## ADDENDUM #1

Reference: Automotive Building Re-Roof  
Dixie State College  
DFCM Project No. 06017640

**AUTO TRADES BUILDING RE-ROOF ADDENDUM #1 ITMES:**

# ADDENDUM #1 ATTACHMENT A

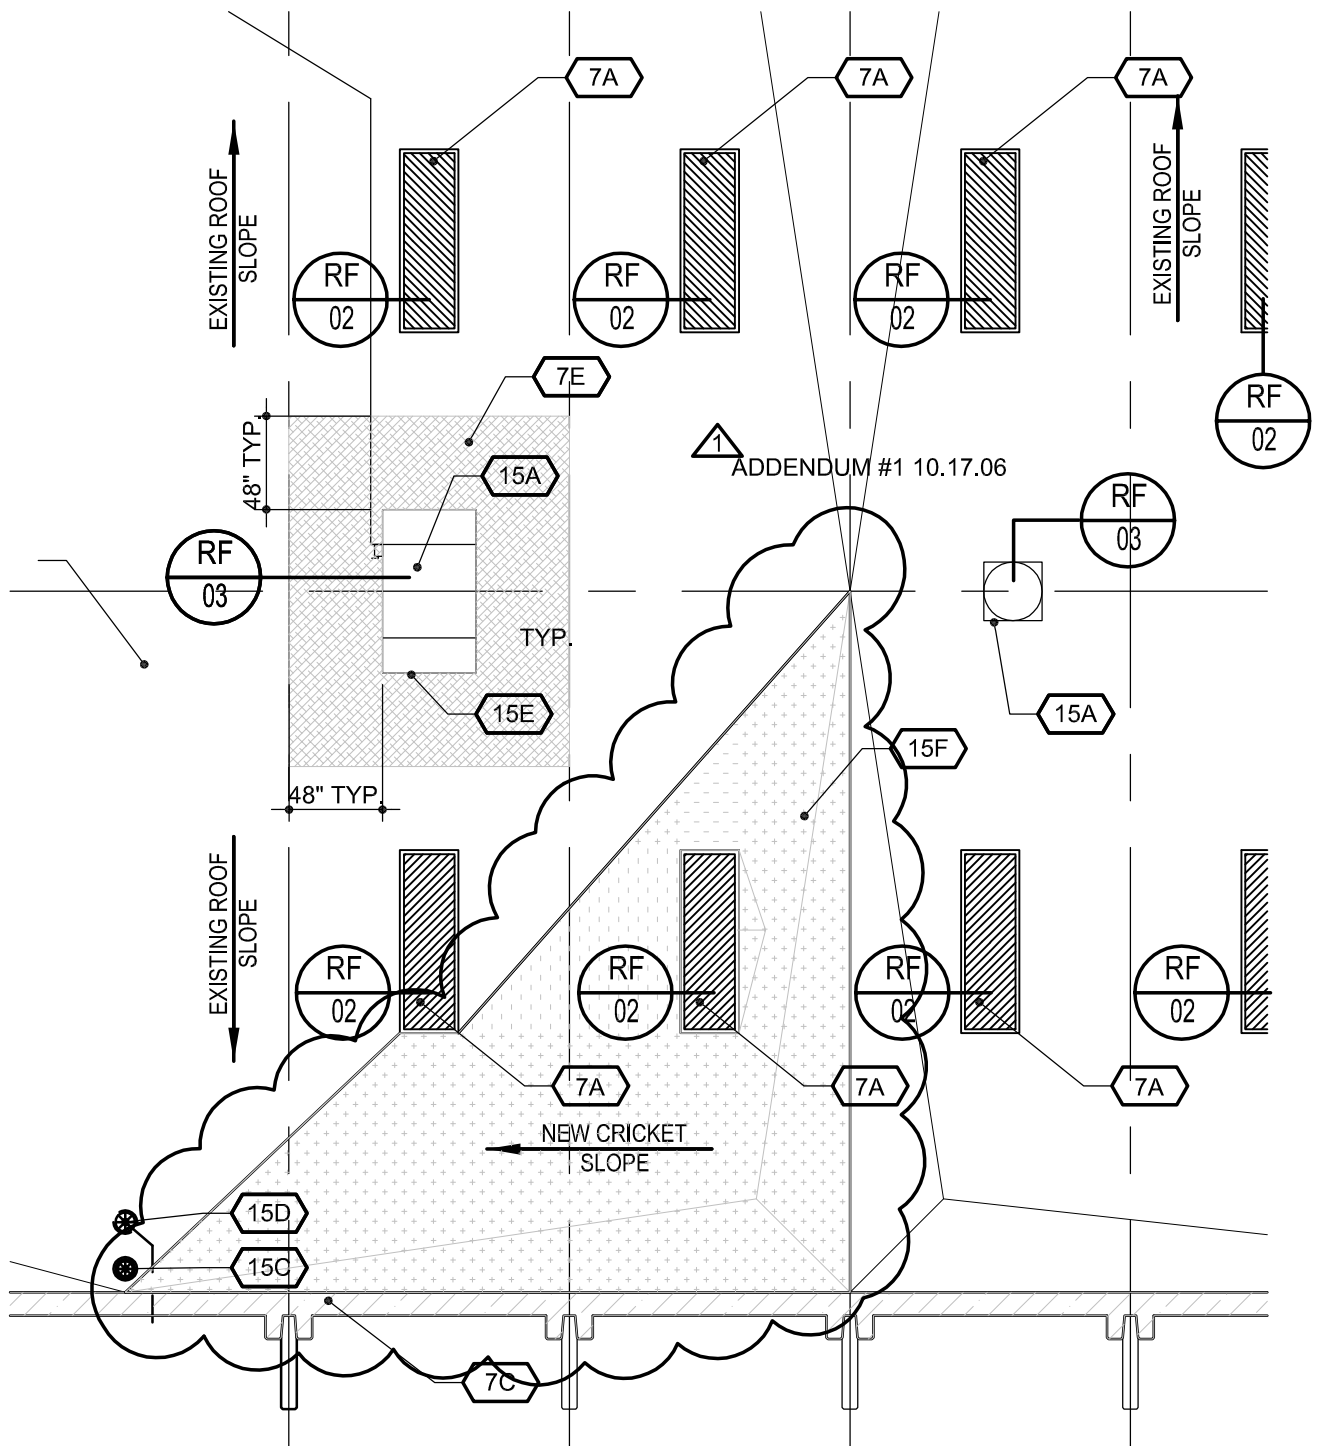
- Item 1 DEMOLITION KEY NOTES. Revise key note 1D to read: "Remove skylights for re-roofing."
- Item 2 DEMOLITION KEY NOTES. Revise key note 1C to read: "Disconnect Utilities from existing Mechanical equipment. Remove condensate and drain lines. Lift unit off of existing steel curbs. Install new curb and frame."
- Item 3 DEMOLITION KEY NOTES. Revise key note 1E to read: "Disconnect and remove existing roof drain bowl unit. Contractor to block drain line prior to removal of gravel ballast."
- Item 4 There has been a question of sheet size for this project. As the PDF shows, the sheet size is 30"x42", and the scale of the demolition plan and roof plan is 1/8"=1'-0". The overall building measures 250' from Grid 1 to Grid 18, and 60' from Grid A to Grid C.

## ADDENDUM #1 ATTACHMENT B

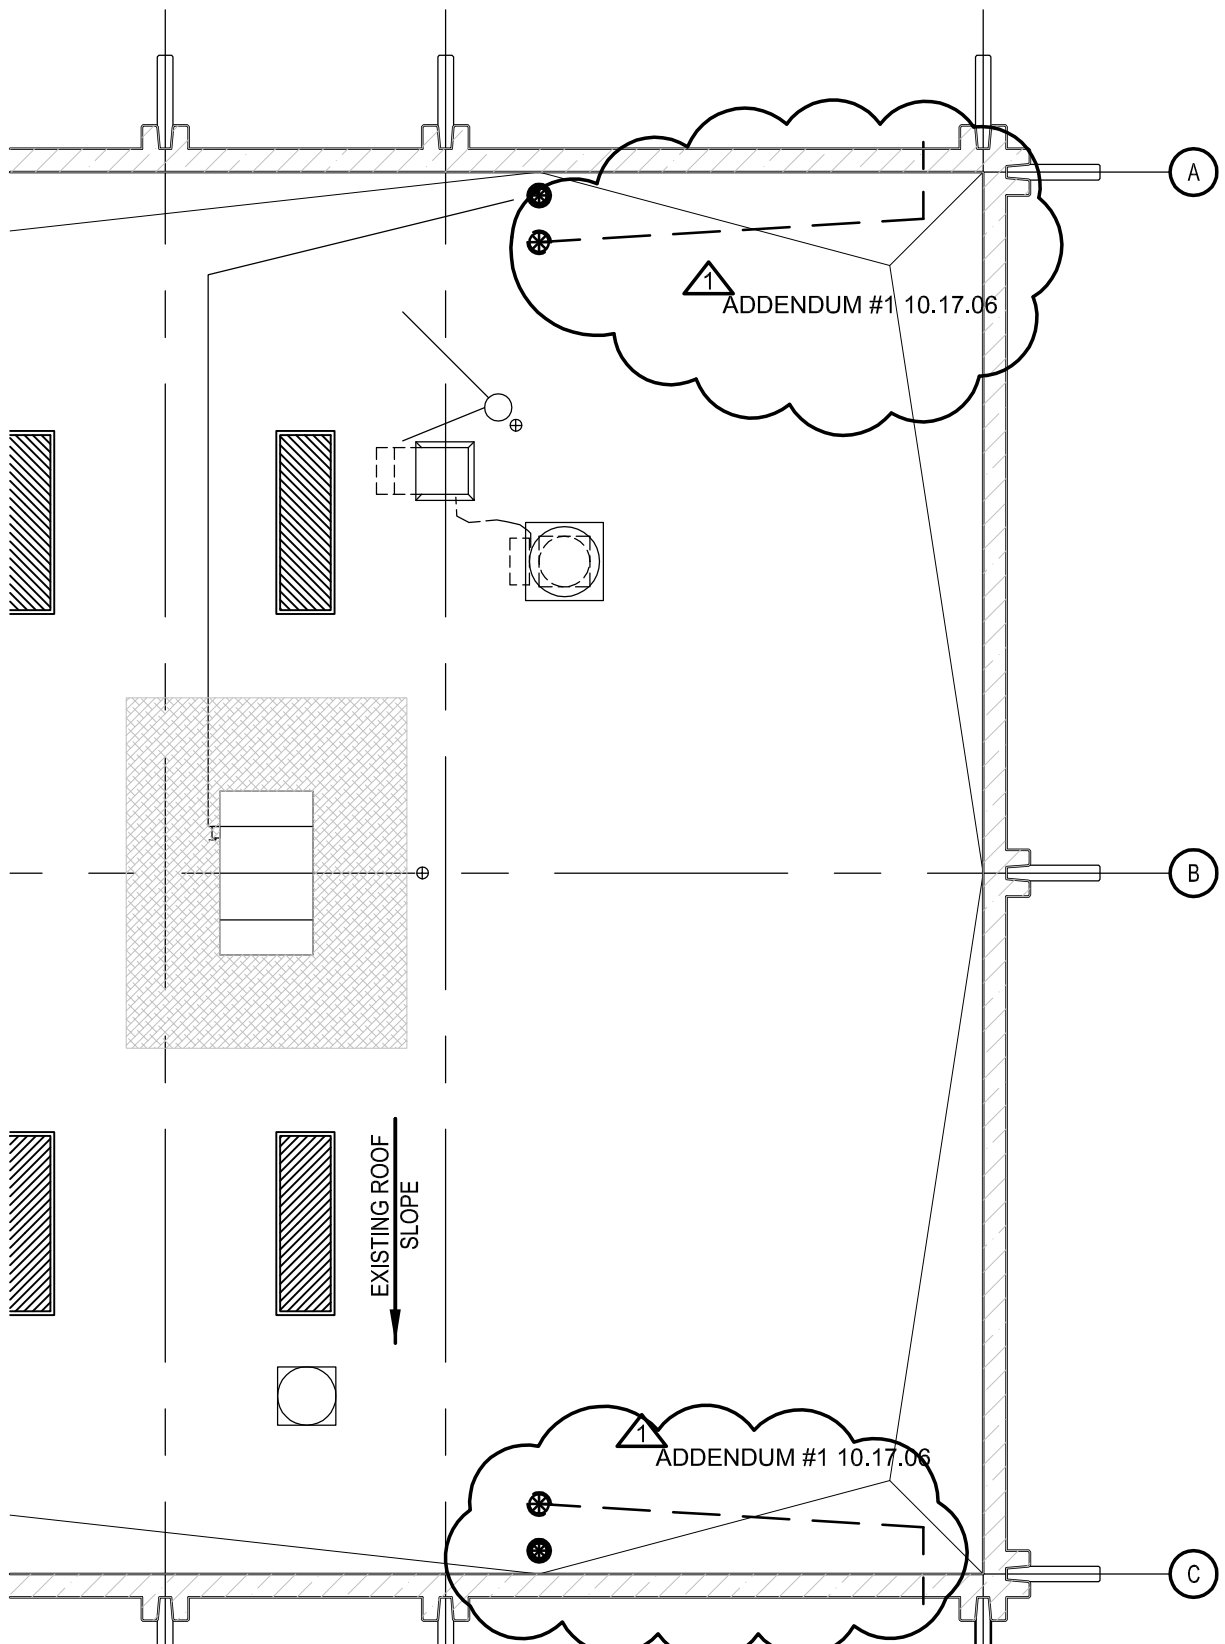
- Item 1 NEW CONSTRUCTION KEY NOTES. Revise key note 7B to read: "Fully Adhere 1/4" Dens Deck Prime cover board and fully adhered new single-ply membrane
- Item 2 NEW CONSTRUCTION KEY NOTES. Revise key note 15C to read: "Install new Retrofit roof drain unit.
- Item 3 NEW CONSTRUCTION KEY NOTES. Revise key note 15D to read: "Core drill existing roof drain bowl w/ metal cover screen. Install new 3" ABS roof drain line, hangers, core drill horz. New opening for drain line and sheep's tongue. Contractor to field verify size of opening with sheep's tongue and existing conditions.

- Item 4 NEW CONSTRUCTION KEY NOTES. Revise key note 15E to read: "Reinstall existing HVAC unit on new treated 2X wood curb at center of unit. Install new painted steel frame at end of evaporative mechanical sections. See detail RF-08
- Item 5 NEW CONSTRUCTION KEY NOTES. Add keynote 15F "fully adhere new tapered cricket as indicated highlighted. New crickets shall match existing adjacent cricket height. Taper insulation to drain. See attachments A & B
- Item 6 revise location of route of 3" ABS overflow line route. See attachments. A & C
- Item 7 There has been a question of sheet size for this project. As the PDF shows, the sheet size is 30"x42", and the scale of the demolition plan and roof plan is 1/8"=1'-0". The overall building measures 250' from Grid 1 to Grid 18, and 60' from Grid A to Grid C.

RF-01

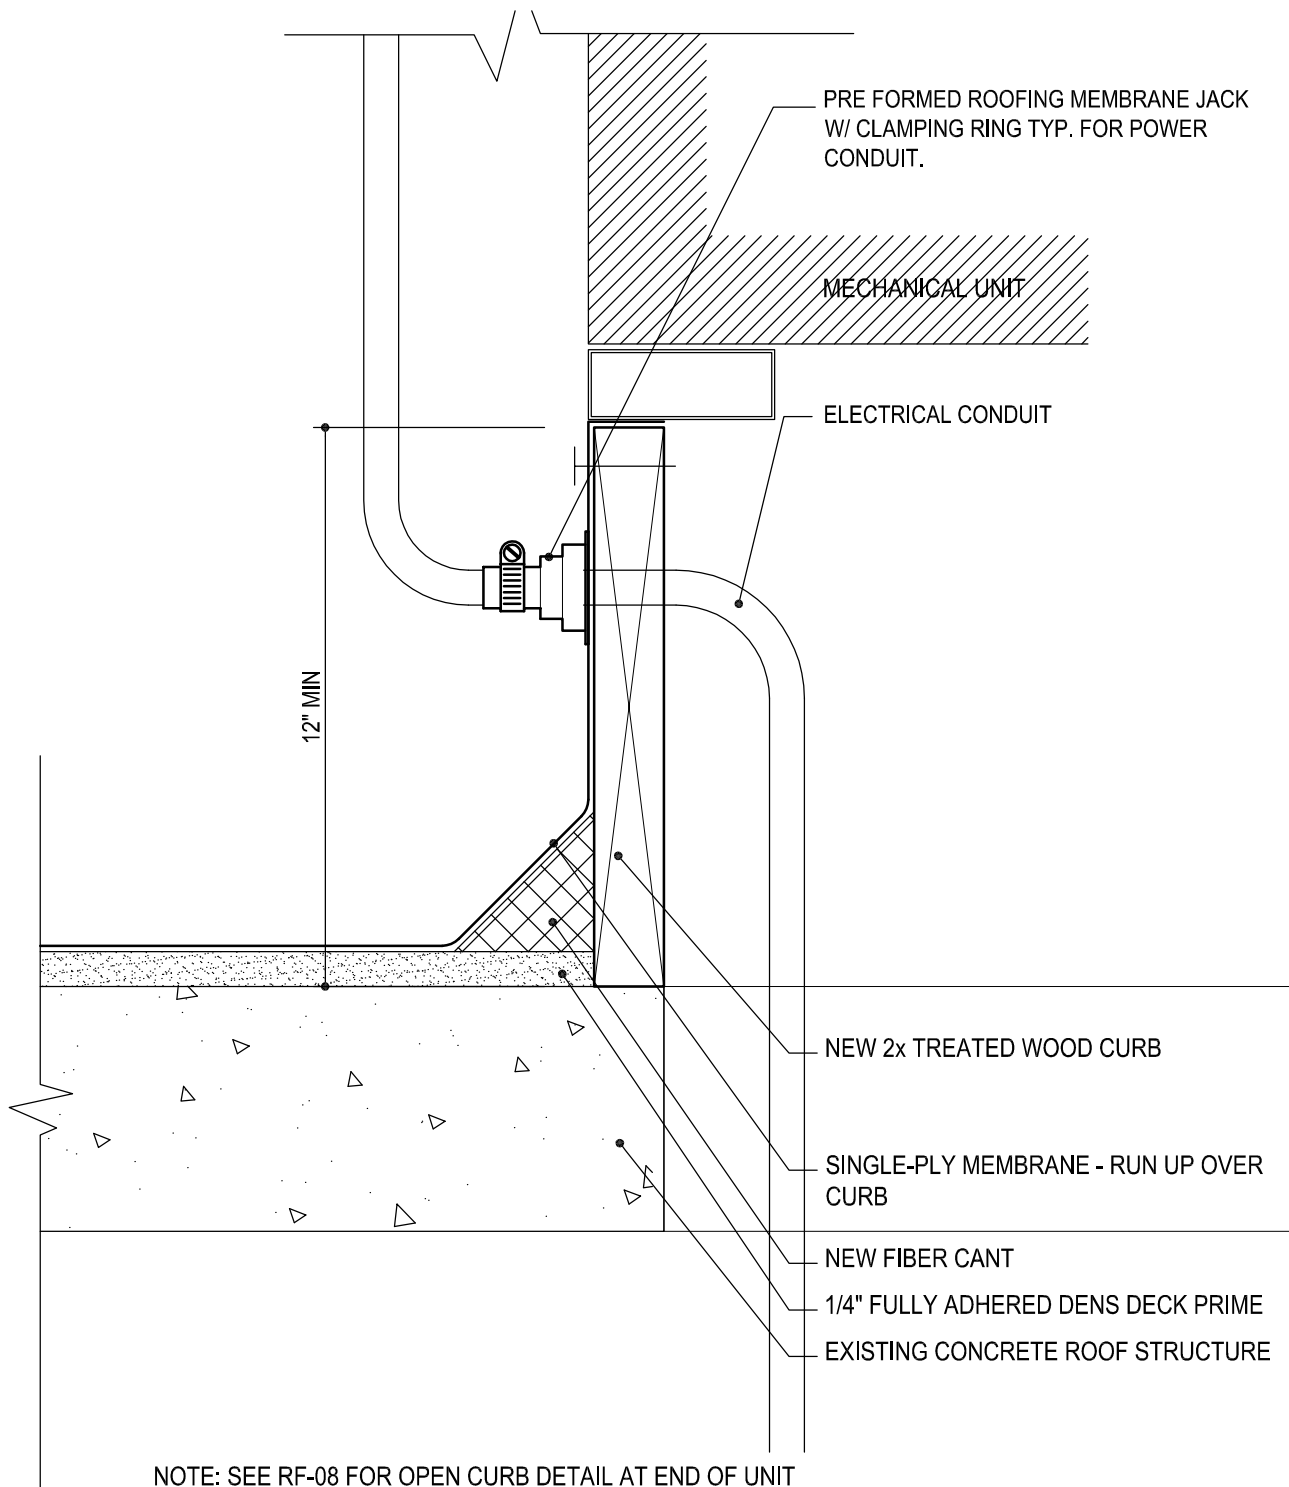
Detail RF-01 Add width dimension of 5 1/2" F.V. – See attached detail RF-01

# RF-05

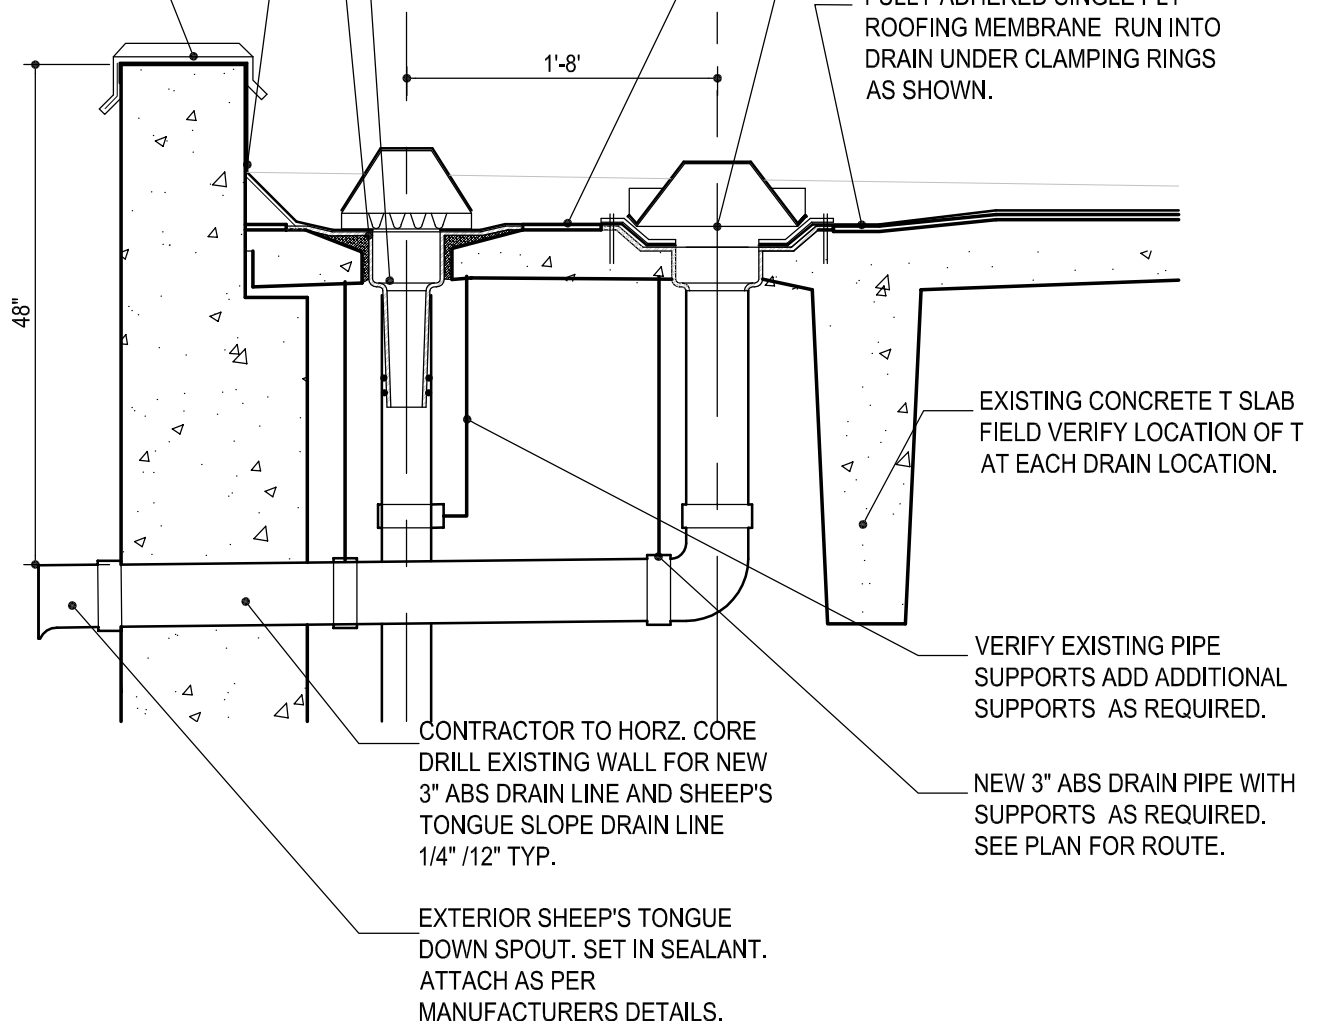
Section 15623 1.06 - A Roof Drains – Primary roof drain shall be changed to read - Olyflow Brand 2" Retro Drain or Equal – One piece seamless body, Aluminum with extra large flange – 17 1/2" 12" long drain stem. Use for replacement of existing primary drains.

Detail RF-05 Replace roof drain detail with new detail. Note: all of the existing roof drain units will now be replaced with new retro drain units. - See attached Detail RF-05

INSTALL NEW 2" RETRO DRAIN.  
 RUN IT INTO EXISTING VERT.  
 DRAIN LINE. FULLY ADHERE  
 DRAIN UNIT AS PER  
 MANUFACTURERS  
 INSTRUCTIONS.  
 MODIFY EXISTING CONCRETE  
 ROOF DECK TO RECEIVE NEW  
 ROOF DRAIN PROFILE. INFILL  
 CONCRETE AS REQUIRED.

CORE DRILL AND REMOVE  
 EXISTING CONCRETE ROOF  
 DECK FOR NEW OVERFLOW  
 ROOF DRAIN UNIT W/ 2"  
 OVERFLOW RING.

FULLY ADHERED SINGLE PLY  
 ROOFING MEMBRANE RUN INTO  
 DRAIN UNDER CLAMPING RINGS  
 AS SHOWN.

CONTRACTOR TO HORZ. CORE  
 DRILL EXISTING WALL FOR NEW  
 3" ABS DRAIN LINE AND SHEEP'S  
 TONGUE SLOPE DRAIN LINE  
 $\frac{1}{4}$ " / 12" TYP.
